To: Nicola Holmes (AC) – Principal Specialist
From: Tessa Craig (AT) – Major Developments Interface Lead
Date: 28 April 2021
Subject: PRR00036350 – 4 Scott Road, Hobsonville

Thank you for the opportunity to provide preliminary feedback (with relation to transport matters) on the pre-application of 435 new dwelling with roads to vest, located at 4 Scott Road, Hobsonville.

Figure 1- Scott Point Precinct Plan 2 (fig 4)

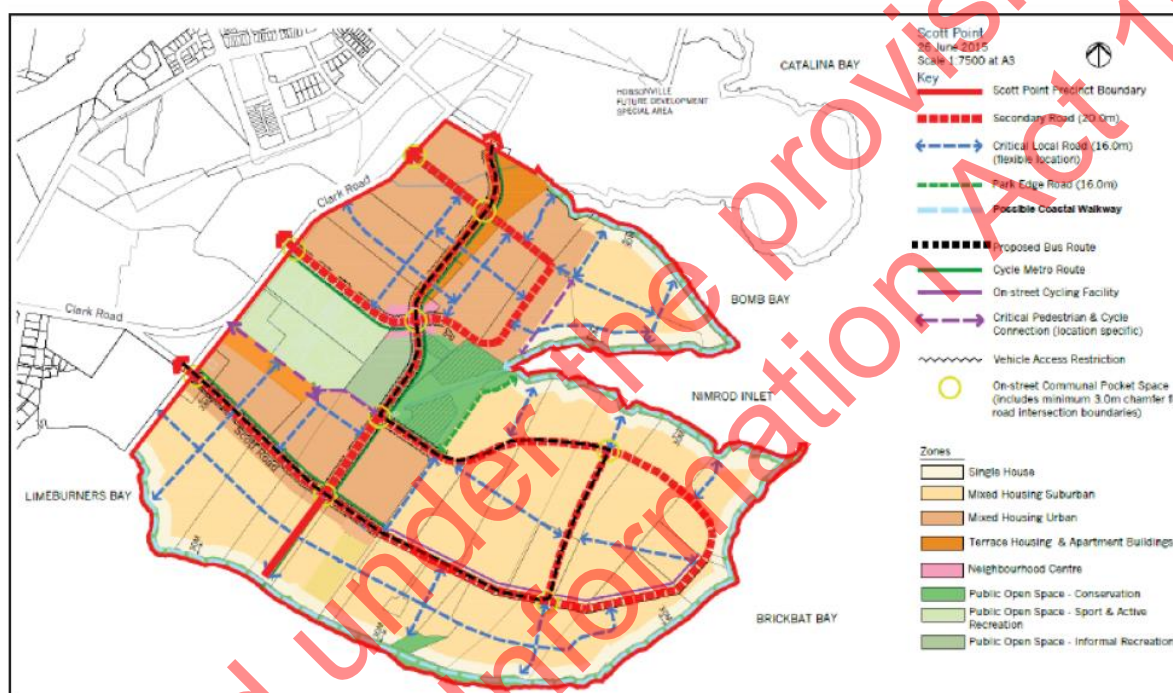
The Scott Point Precinct Plan indicates a single connection on to Scott Road from this site. It would be best to reduce the number of vehicular intersections with Scott Road and for a second access onto Scott Road to be a pedestrian/cycle access only (8m accessway) to retain the connectivity benefits. The blue dashed line indicates the critical local road required to be provided both N-S and E-W through the site.

The precinct plan suggests that Road E needs to be extended to southern property boundary, or future proofed in its design to allow extension and connection to the adjacent property to the south as indicated in the precinct plan as a "Critical Local Road(16m)". The applicant explained at the pre-app meeting that it would be difficult for Road E to tie into the neighbouring properties to the south, whereas the extension of Road A would be able to tie in. A walking and cycling connection should be included where Road E terminates to provide connectivity.

Figure 2- Mark up of layout plan

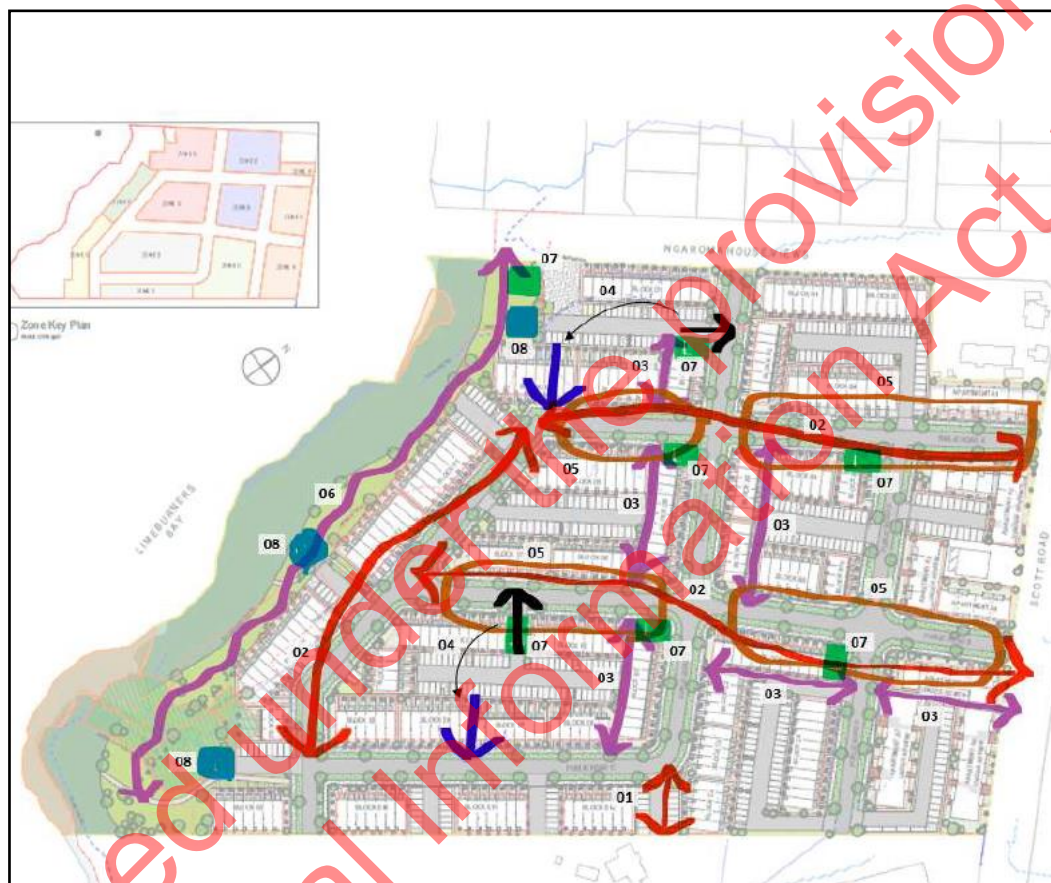
With this in mind, the roads within the development should have a design speed of 30km/hr and appropriate traffic calming measures to achieve this including vertical and horizontal speed calming measures. Maximise the use of trees to provide shade in summer, contribute and reinforce the residential nature of the proposed streets. Roads A and B could be redefined to avoid encouraging speeding by providing a long/straight stretch of road and introducing bends/curves to help reduce speeds (see red arrows in Figure 2 below). Indented parking spaces should be provided throughout the development.

The rear pedestrian access to lots should be redesigned so that they allow for a 2.5m wide minimum connection across proposed blocks and between proposed streets (please see purple arrows below). A minimum 2.5m wide public "Coastal Walkway" as defined in the Scott Point Precinct Plan is required and should ensure the walkway has passive surveillance from

proposed lots facing Limeburner's Bay. Active and passive recreation within the proposed blocks at suggested locations (in green) facing north and opportunities for active recreation within the proposed blocks at suggested locations (in blue) at dead ends could be incorporated.

It is suggested the vehicle crossings located along the black points below be relocated to avoid main roads within this subdivision (suggested to be located to where blue arrows are shown) and to produce a road with potential for slow/safer environment for pedestrians/cyclists.
